Access Compliance Report Public Rights-of-Way (Curb Ramps)

Intersection ID: 2761 Main Street: BEAUVISTA_DR Cross Street: MAPLE_COVE_LN Location: SW

ADA ID: 2BC98E0B5BCB Ramp Type: PerpDiag Initial Pass/Fail: Fail Overall Compliance: No Severity Score: 33.75

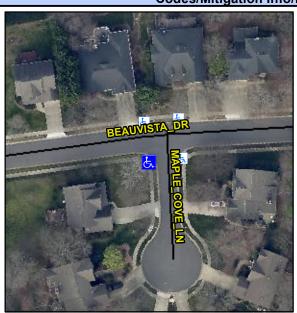
Not Found, R304.5.1, R304.5.3

Field Measurements/Component Compliance						
	Compliance Description		Data	Comp	oliance Description	Data
	N/A	Ramp Length (in)	42.0	Yes	Ramp Slope (%)	5.0
	No	Ramp Width (in)	39.0	No	Ramp XSlope (%)	9.6
	N/A	Flare Type LT	N/A	N/A	Flare Type RT	N/A
	N/A	Flare Slope LT (%)	N/A	N/A	Flare Slope RT (%)	N/A
	N/A	Flare Traversable LT?	N/A	N/A	Flare Traversable RT?	N/A
	N/A	Landing Length (in)	N/A	N/A	DWS Provided?	N/A
	N/A	Landing Width (in)	N/A	N/A	DWS Contrast?	N/A
	N/A	Landing Slope (%)	N/A	N/A	DWS Length (in)	N/A
	N/A	Landing X Slope (%)	N/A	N/A	DWS Full Width?	N/A
	N/A	Landing Curb? (Y/N)	N/A	N/A	DWS Offset (in)	N/A
	N/A	Shared Landing?	N/A			
	N/A	Gutter Ponding?	N/A	N/A	Gutter Slope (%)	N/A
	N/A	Gutter Lip Ht (in)	N/A	N/A	Gutter X Slope (%)	N/A
	N/A	Painted X Walk1?	No	N/A	Painted X Walk2?	No
		X Walk 1 Direction	To E		X Walk 2 Direction	To N
	N/A	X Walk 1 Width (in)	N/A	N/A	X Walk 2 Width (in)	N/A
		X Walk 1 Slope (%)	8.0		X Walk 2 Slope (%)	1.4

Remove & Replace Curb Ramp With Two New Directional Ramps or Equivalent.
